TOWN OF BROOKLINE

PURCHASE ORDER CHANGE FORM

Re: John R. Pierce School Project
Designer Services Contract Amendment No. 16

AMENDMENT NO. 17

DRAINAGE PROFILES

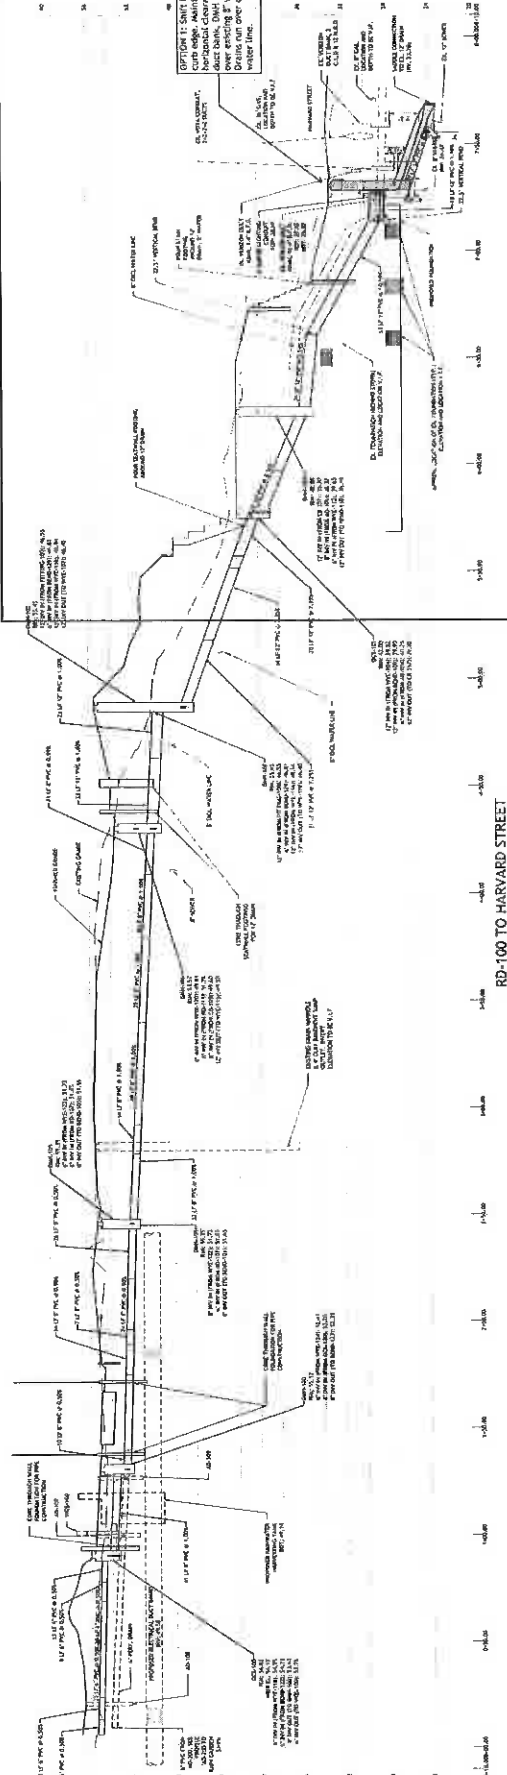
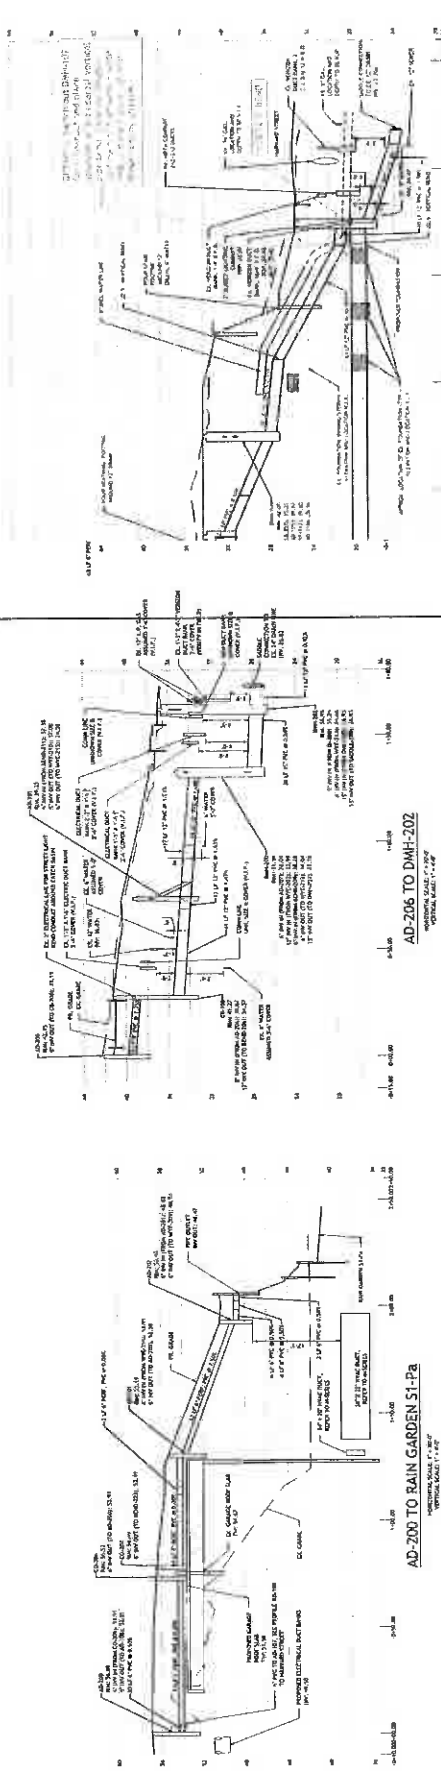
There were unexpected obstructions found at Harvard Street in the form of an additional electrical duct bank and an old rubble foundation wall. The found utilities and rubble walls impact the foundation drain system, drainage system, and streetscape improvements along Harvard St, which require design revision.

The depth and configuration of the found footings and grade beams at 68 Harvard Street would have required $\pm 6"$ of underpinning, relative to the proposed work. To avoid the cost and risk of underpinning that small height, the school's walkway will be adjusted upwards, and insulation will be added, in lieu of lowering the footings. Wall sections will be developed to redesign the base of the retaining wall directly adjacent to the existing footings, grade beams, and rubble foundation wall.
